KMR.CDD.MiQ.1928-1932.01

AMENDED PLAN OF PROPOSED BUILDING ON PLOT

NO.10/2/4 + 10/2/5 11. SHEET NO. R-B-7.

With reference to your application dated 7. 7. 193 /, with a plan for the proposed building/additions and alterations on plot No. 10/2/4 Survey Sheet No. RB7, Panbanga quarter I have to inform you that until the following requirements are complied with plans cannot be passed:—

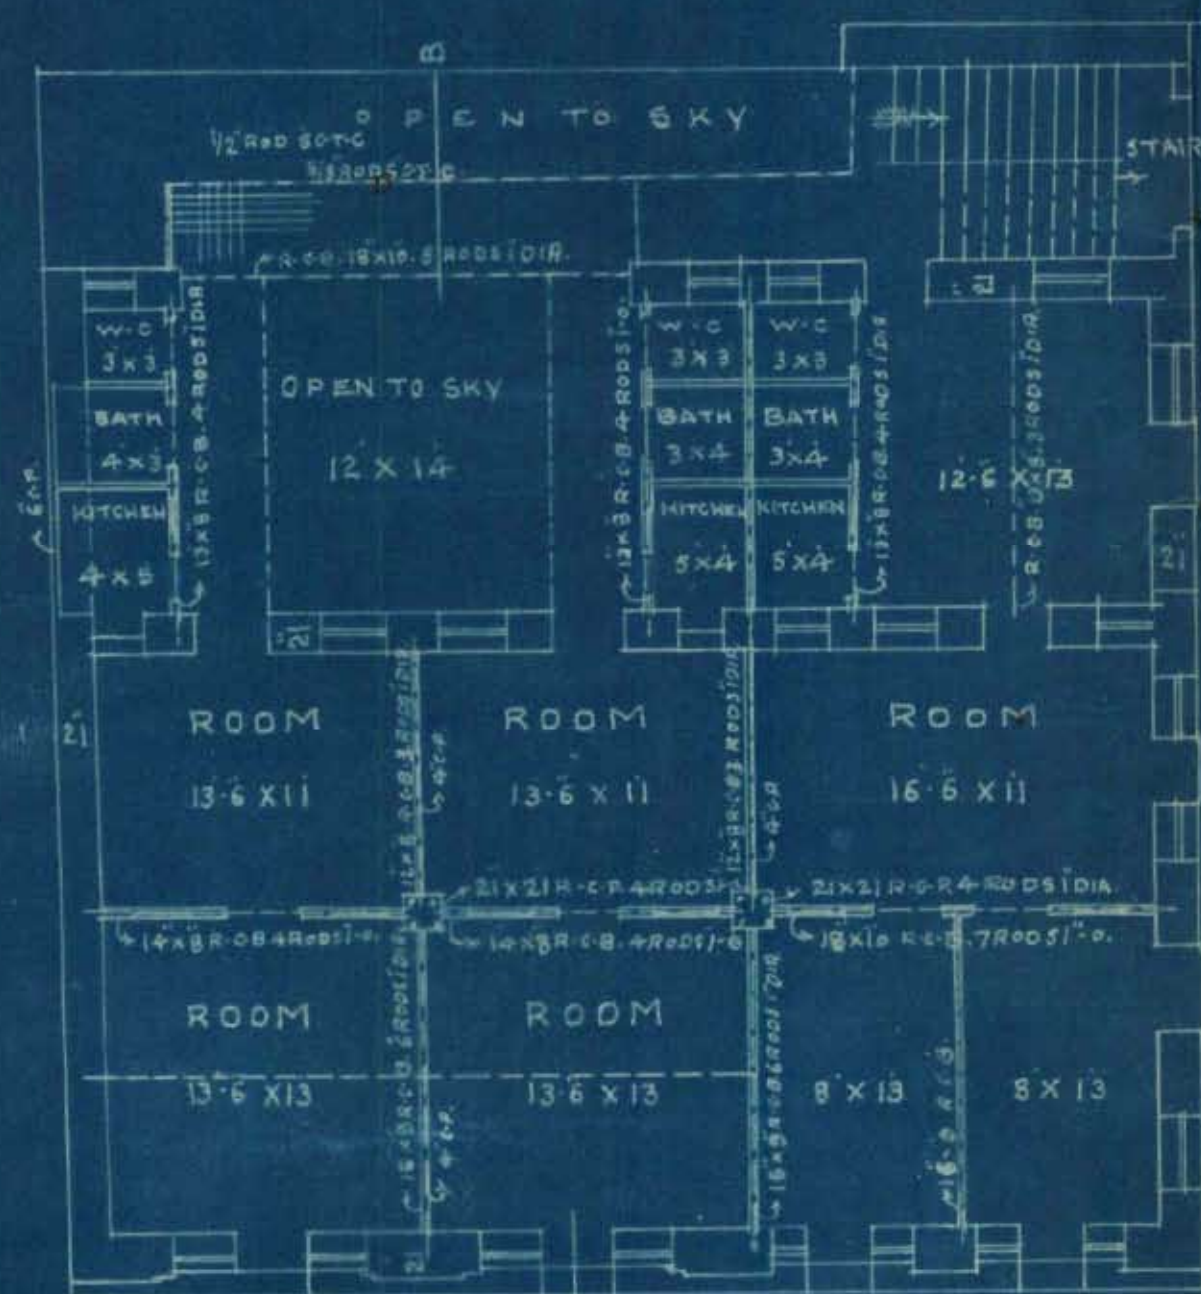
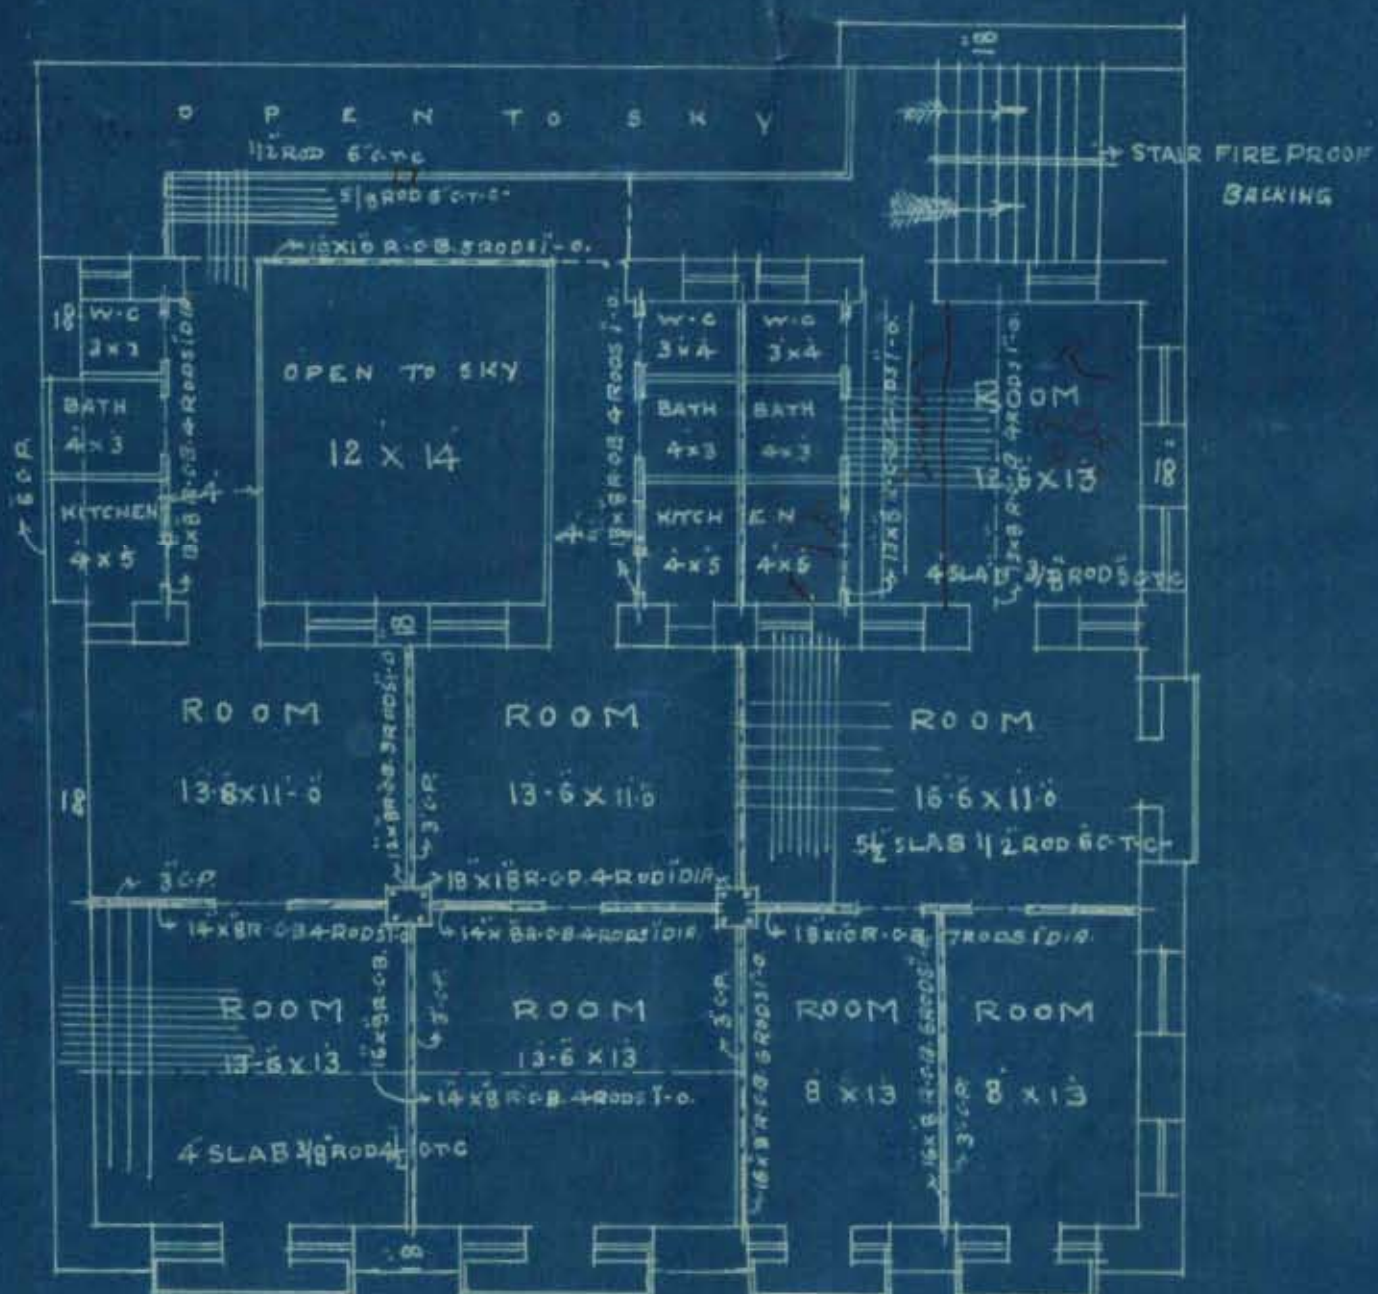
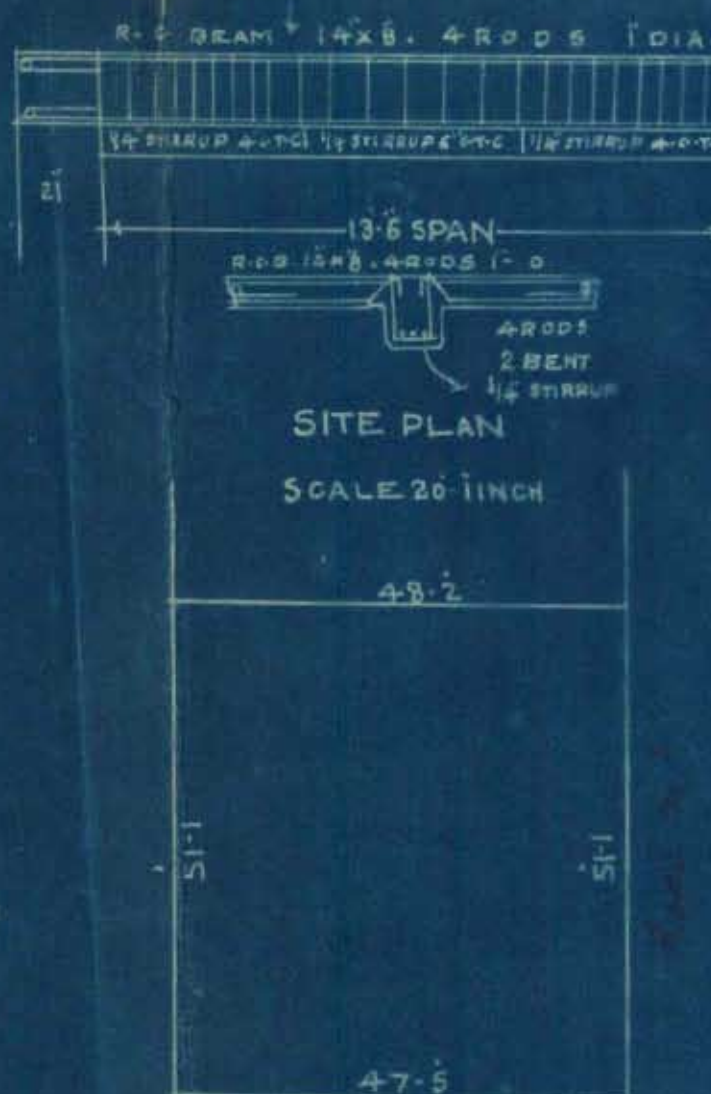
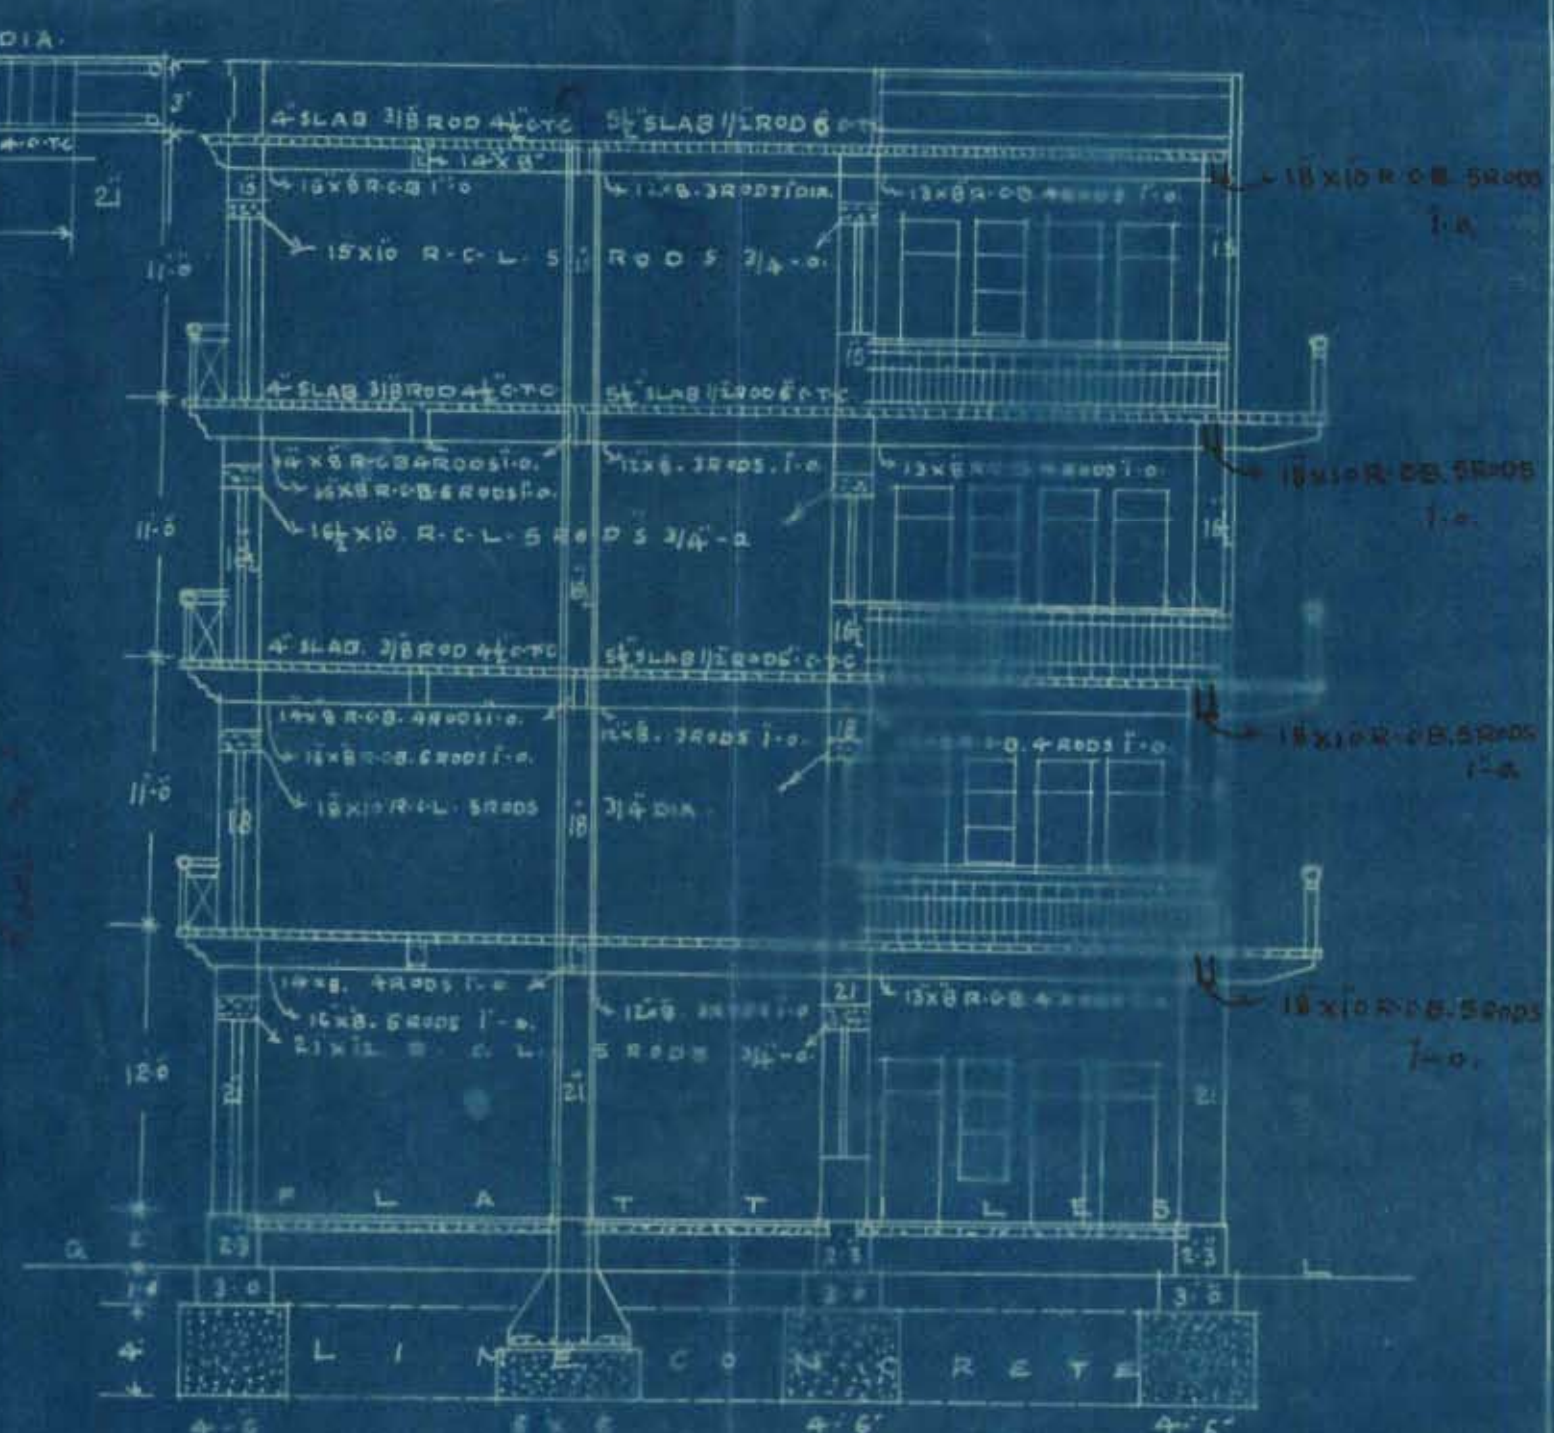
1. Gallery at the back be supported
 by a central post as shown.
 2. Verandah and room can be allowed.
 3. Balcony projection to be limited to 9".

Measurement must be correct and
adjoining of the plot be given.

35 & 285 ft. space on the
left side passed by, we marked
down entrance door for road

- (1) Gallery at the back be supported by a central post as shown.
- (2) Verandah and rooms can ~~not~~ be allowed.
- (3) Balcony projection to be limited to ~~10~~ 9"
- (4) measurements must be correct and
- (5) open space must be kept as per as per passed plans.
- (6) W.C must not have entrance direct from rooms.
- (7)
- (8)
- (9)

AMMENDED PLAN OF BUILDING ON PLOT

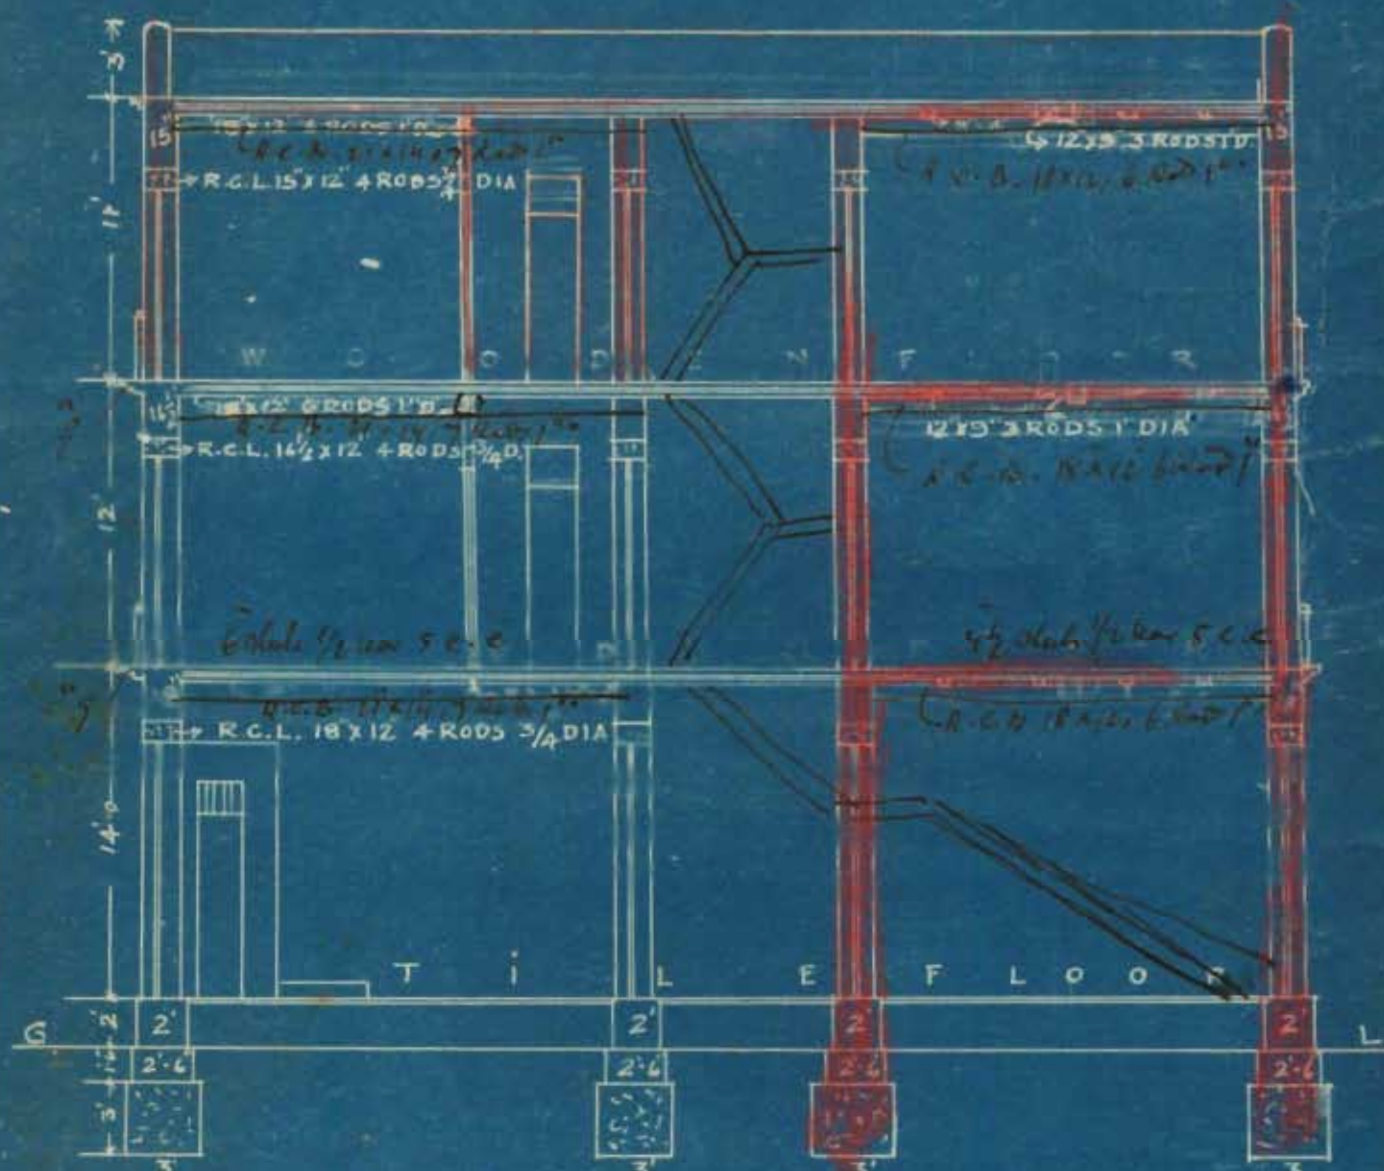
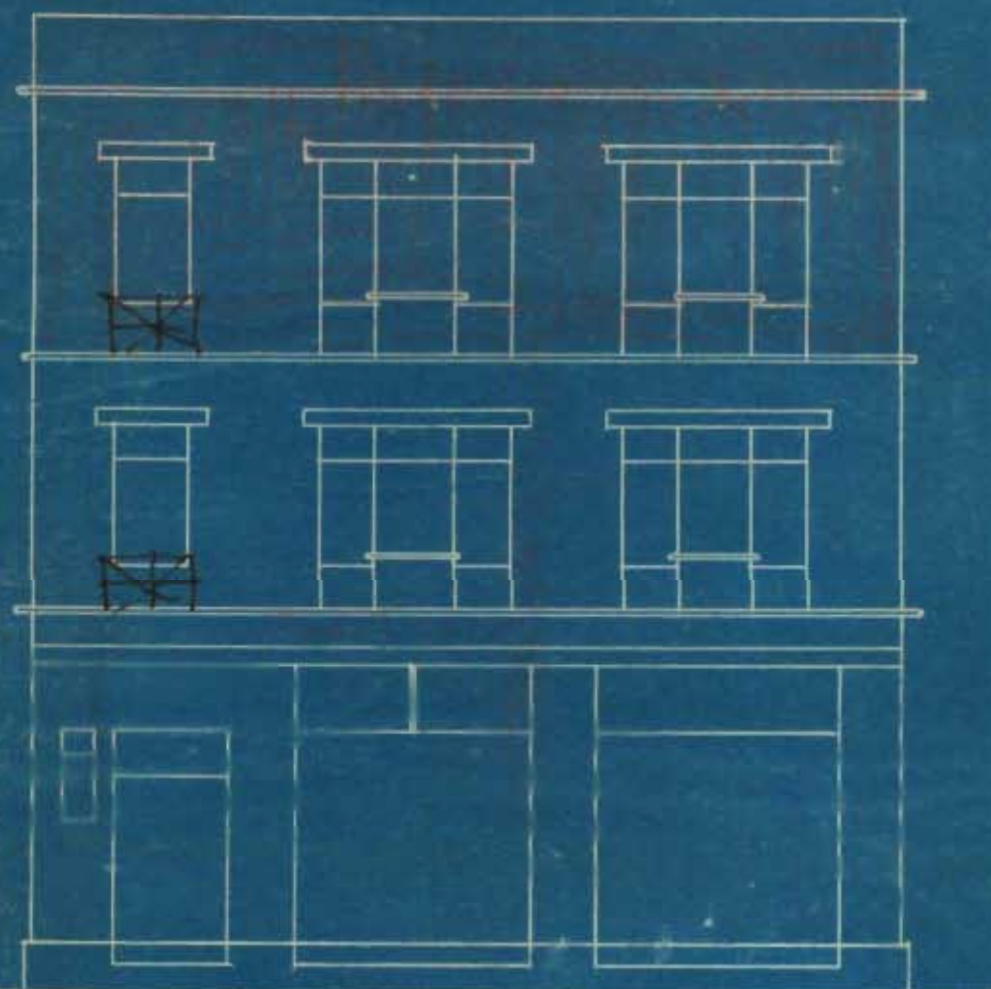
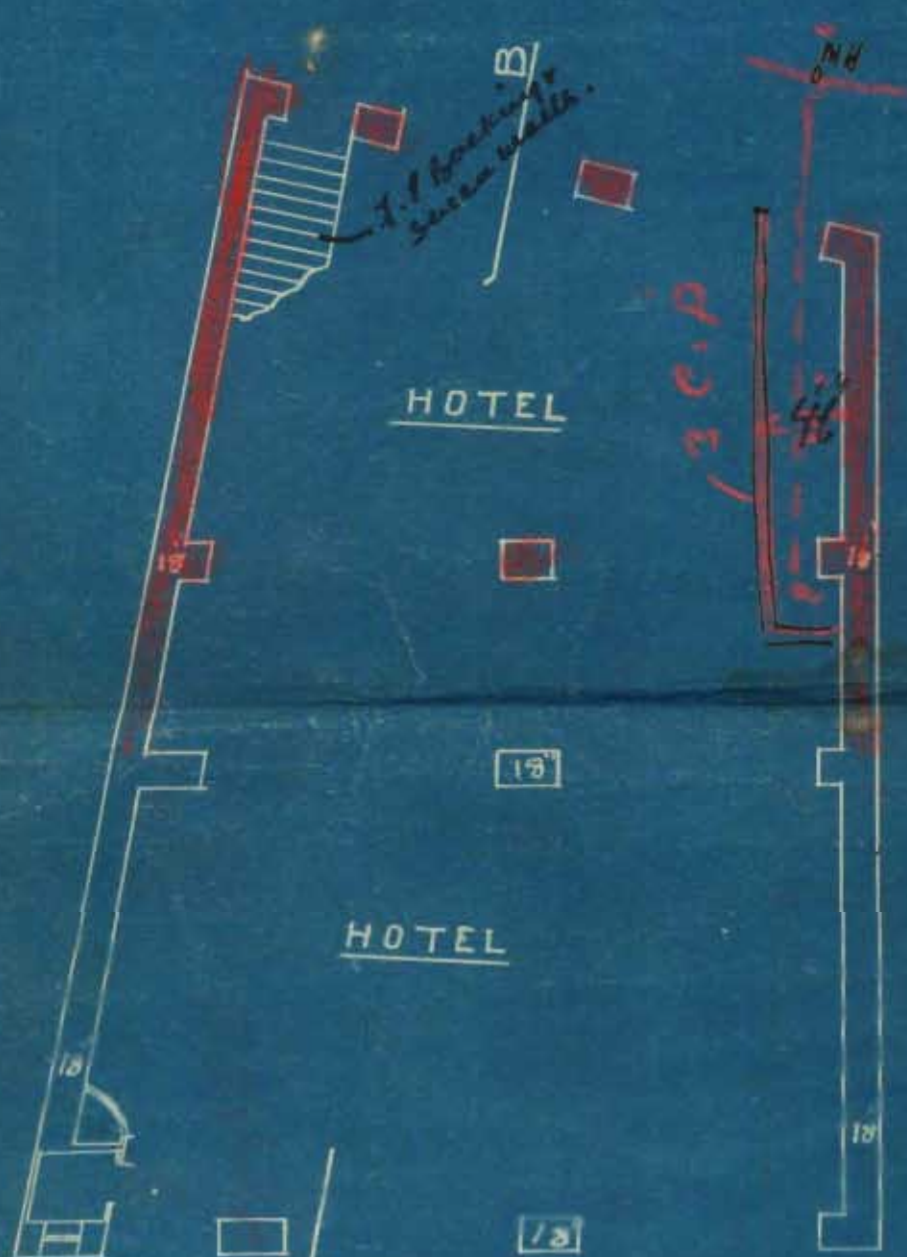
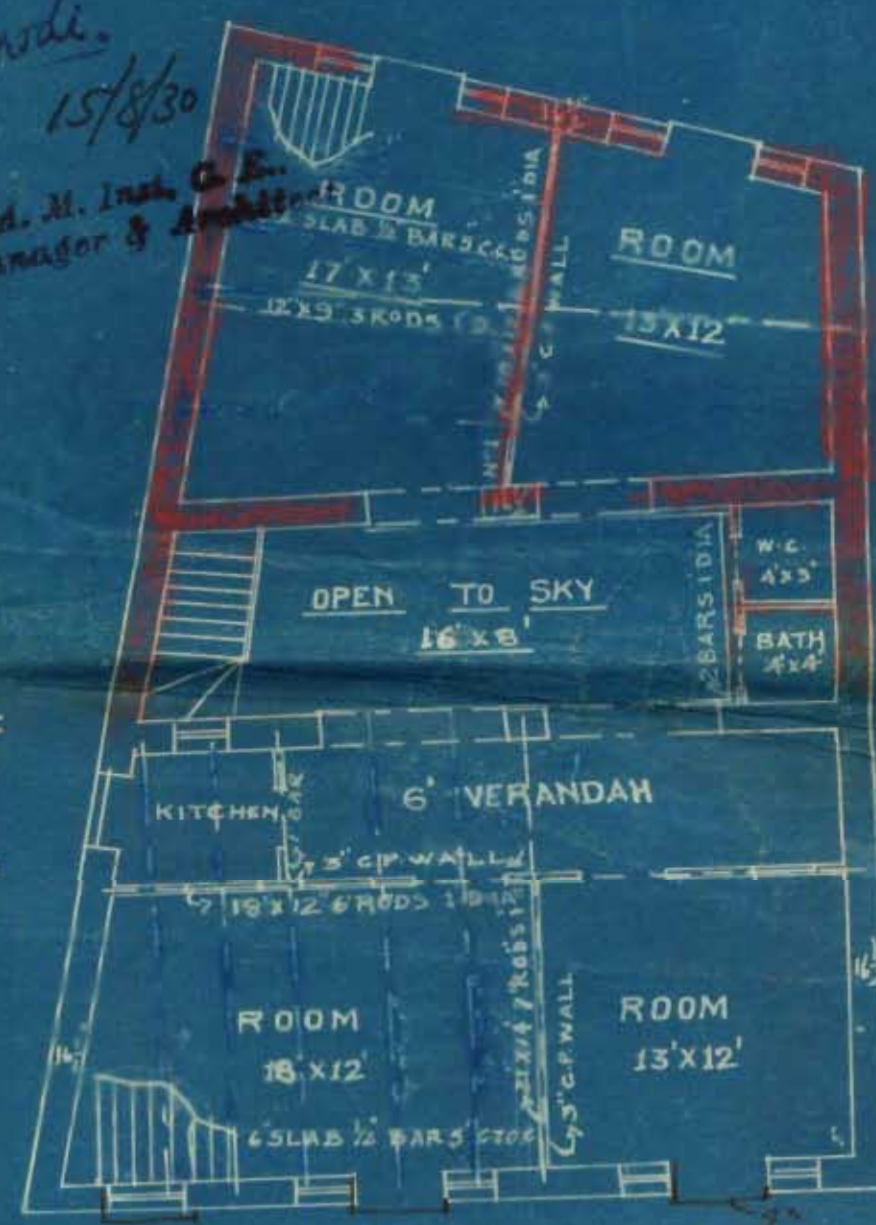
- (1) The building is not built as per sanctioned plan.
- (2) On the River Road Side, the timber & the well are old & so it cannot be have an upper story.
- (3) Plan & section do not tally.
- (4) Balcony projection should be 9"
- (5) Balcony 14' is constructed on site but not shown on plan neither on elevation.
- (6) The Architect should explain why he has tried to pass off wrong things.
- (7) Measurements of plot should be corrected.
- (8)
- (9)

1. Balcony projection should be 9"

2. Balcony 'a' is constructed on site but not shown on plan neither on elevation.

Remarks Measurements of the plot are incorrect ✓
